SOUTH VALLEY WATER RECLAMATION FACILITY
PROJECT 4D
WEST JORDAN, UTAH

MECHANICAL
BIOREACTOR NO. 4 AIR
DIFFUSER SYSTEM PLAN

SOUTH VALLEY WATER RECLAMATION FACILITY		
WEST JORDAN UTAH		
THIS DRAWING IS THE PROPERTY OF SANITAIRE AND IS SUBMITTED IN CONFIDENCE. IT IS NOT TO BE REPRODUCED, COPIED OR DUPLICATED WITHOUT PERMISSION OF SANITAIRE.		
BIOREACTOR 1-4 STRUCTURAL, DROPLEGS & MANIFOLDS KEY PLAN		
ITT Corporation		
SANITAIRE® BROWN DEER, WISCONSIN 53223 ABJ®		
DRAWN BY: MRL	DATE: 12-4-07	DESIGN: NEW/REV
CHKD BY: MTR	DATE: 12-12-07	STD.
APPROV BY: DE	DATE: 12-13-07	SHEET: 2 OF 40
JOB: 07-67425		
S-2

BIOREACTOR 1-4
AERATION GRIDS
KEY PLAN

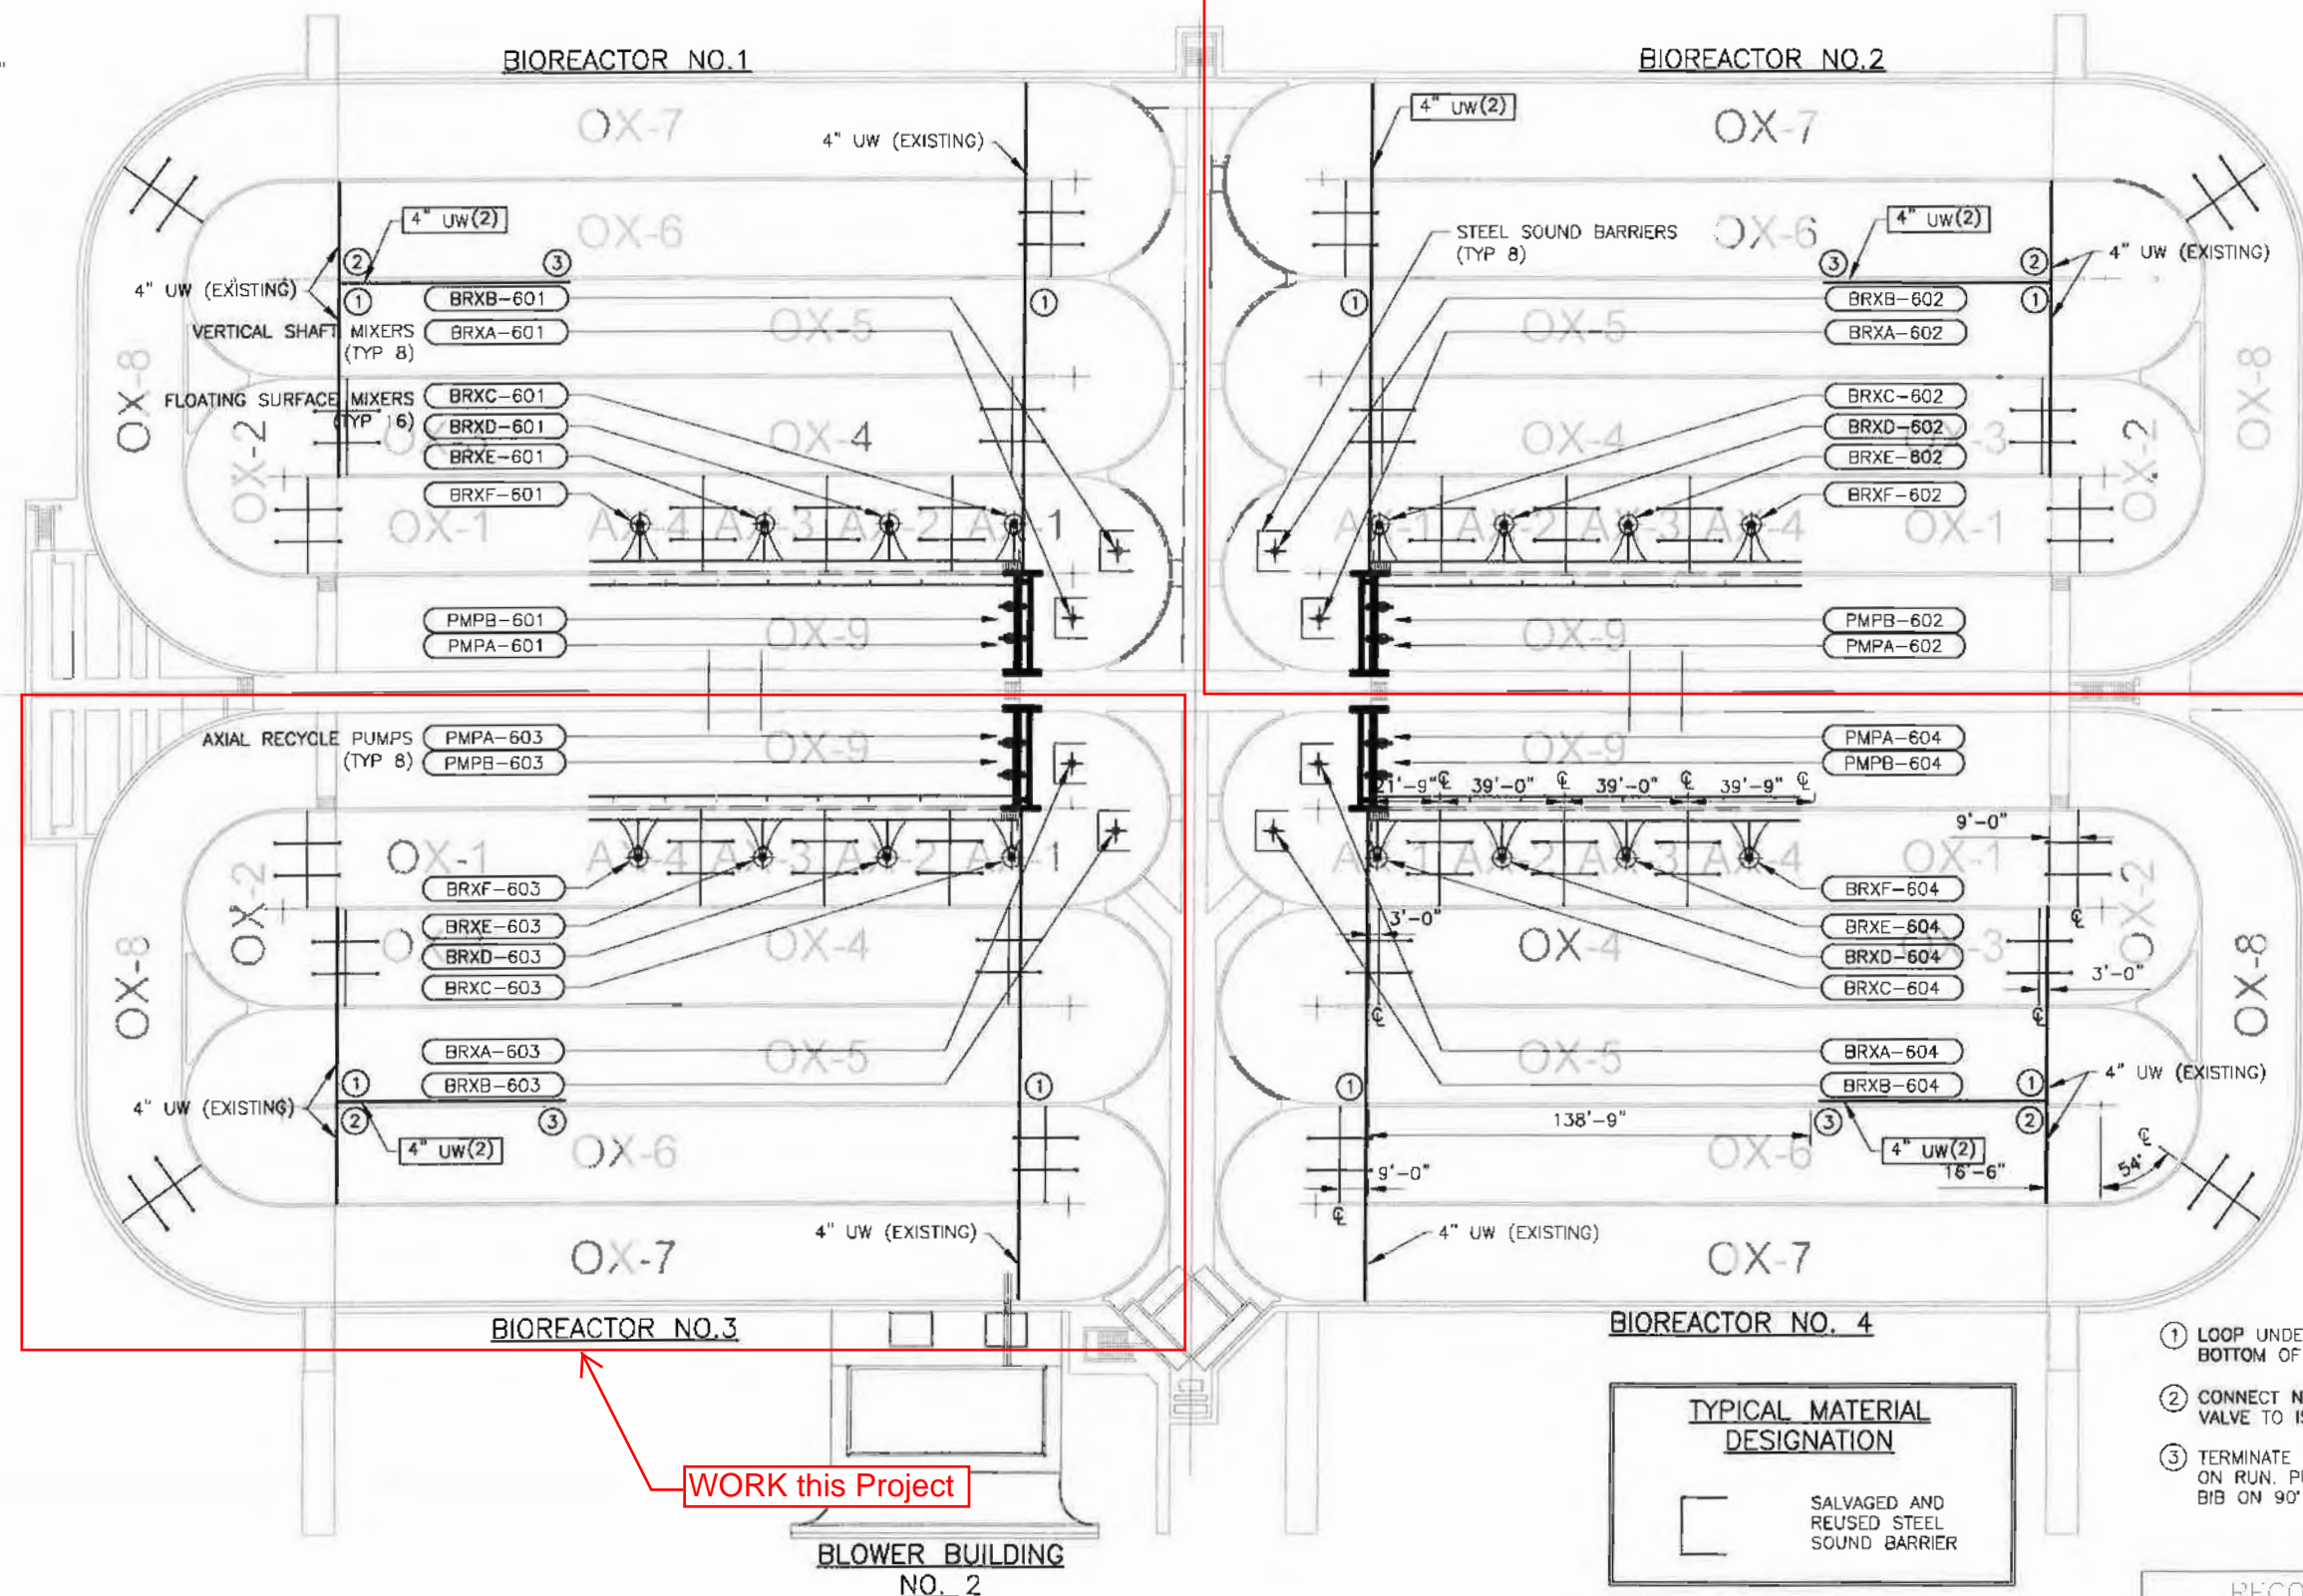
- ① LOOP UNDER STAIR. PROVIDE DRAIN ON BOTTOM OF LOOP. PAINT.
- ② CONNECT NEW PIPE AT LOOP. ADD 4" BALL VALVE TO ISOLATE NEW PIPE. PAINT.
- ③ TERMINATE NEW PIPE WITH TEE. PUT PLUG ON RUN. PUT RISER, BALL VALVE AND HUBB BIB ON 90° OUTLET IN VERTICAL. PAINT.

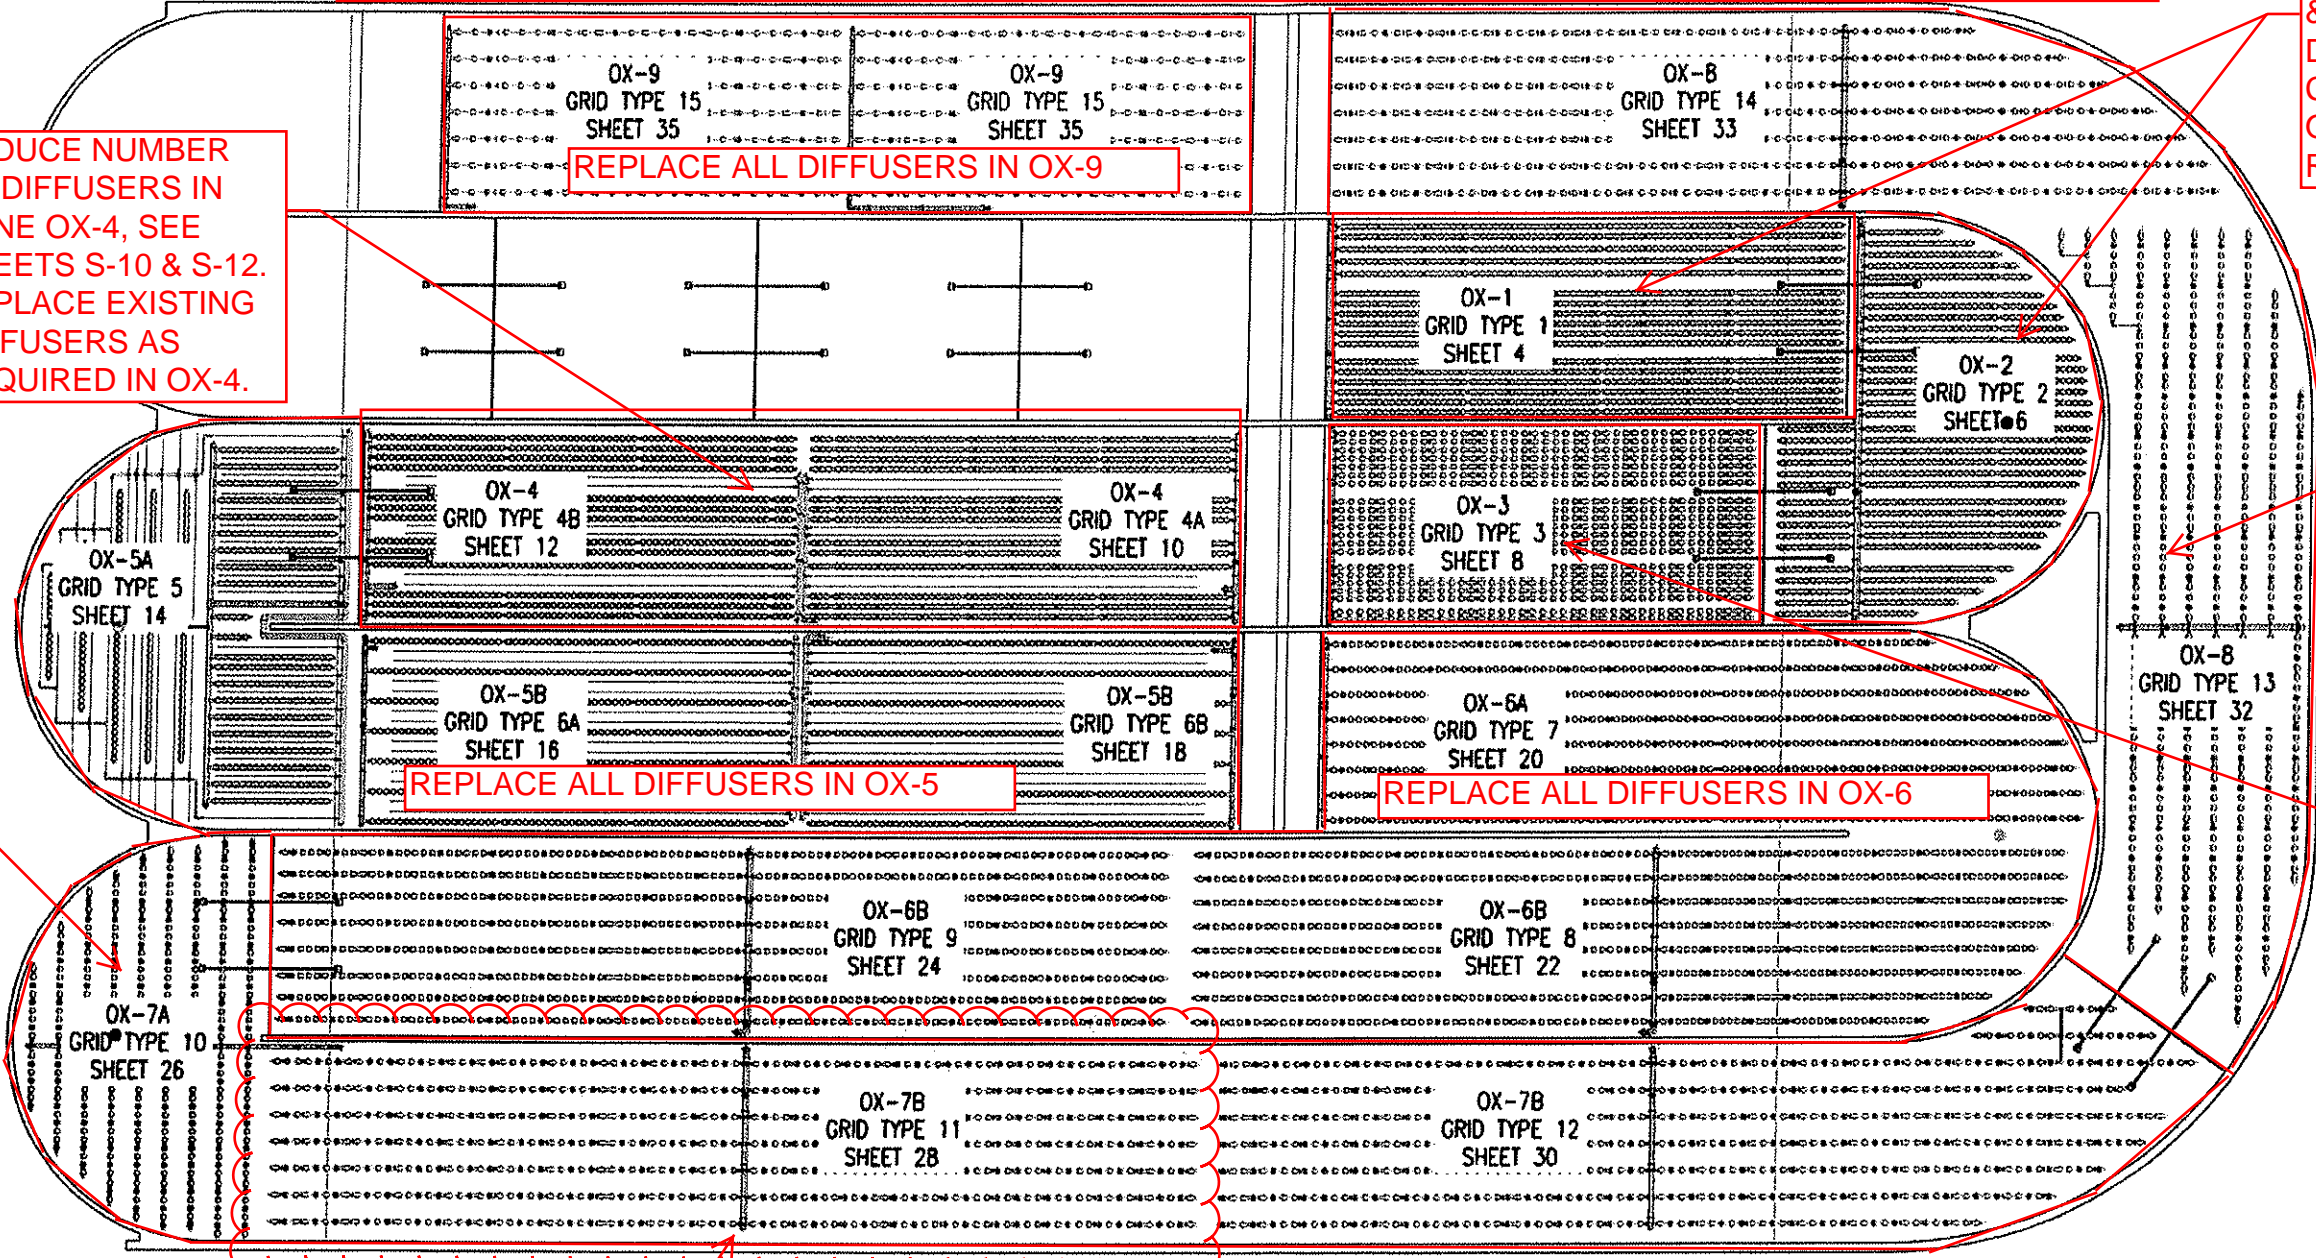
IN BIOREACTOR 3 ONLY REMOVE EDPM MEMBRANE DIFFUSERS, O-RINGS, AND PVC RETAINER RINGS. ZONES OX-1 & OX-3 WILL NOT HAVE DIFFUSERS REPLACED. CONTRACTOR SHALL TURN OVER EXTRA PVC RETAINER RINGS TO OWNER.

REDUCE NUMBER OF DIFFUSERS IN ZONE OX-4, SEE SHEETS S-10 & S-12. REPLACE EXISTING DIFFUSERS AS REQUIRED IN OX-4.

REPLACE ALL DIFFUSERS IN OX-9

REPLACE ALL DIFFUSERS IN OX-8

REPLACE ALL DIFFUSERS IN OX-5

REPLACE ALL DIFFUSERS IN OX-6

REPLACE EXISTING DIFFUSERS IN OX-3

REPLACE ALL EXISTING DIFFUSERS IN OX-7. INCREASE NUMBER OF DIFFUSERS IN ZONE OX-7, SEE SHEETS S-26, S-28 & S-30

IN BIOREACTOR 2 ONLY ON THIS GRID IN OX-7 INSTALL ONLY SSI AERATION INC. 9" EPDM/TEFLON COATED MEMBRANES

OX-1
GRID TYPE 1
PLAN VIEW 3

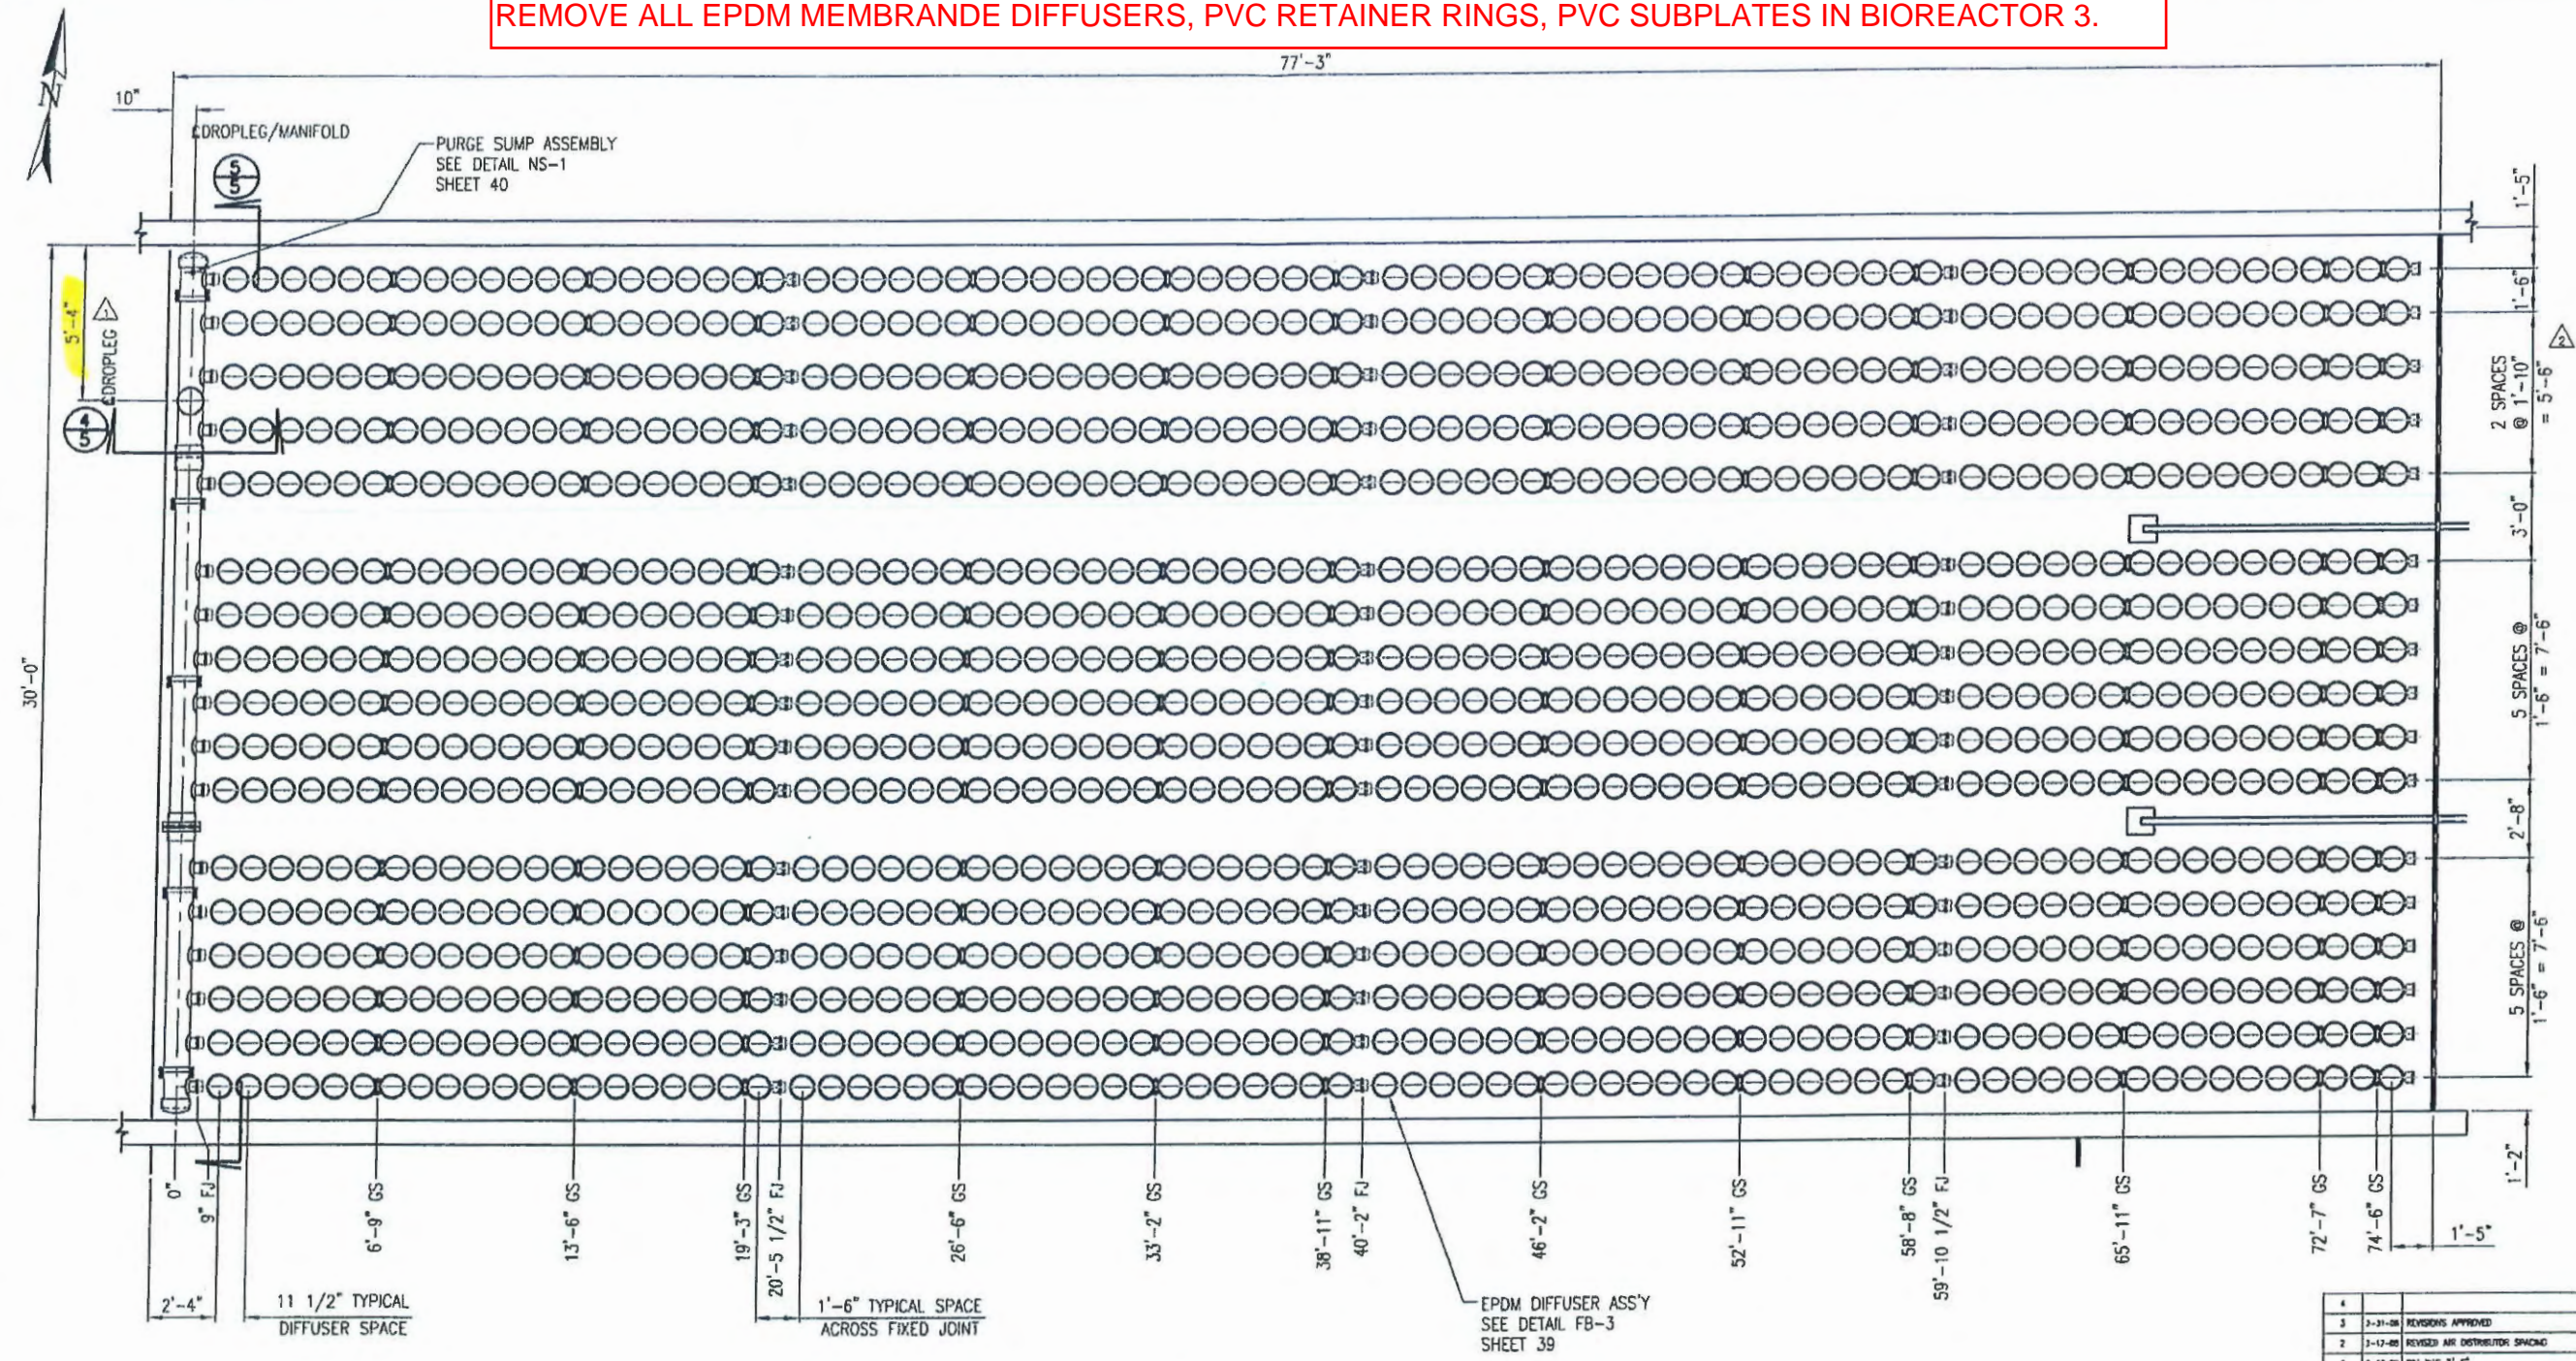
FOR THIS GRID:
REMOVE AND REPLACE ALL EPDM MEMBRANE DIFFUSERS IN BIOREACTOR 2.
REMOVE ALL EPDM MEMBRANE DIFFUSERS, PVC RETAINER RINGS, PVC SUBPLATES IN BIOREACTOR 3.
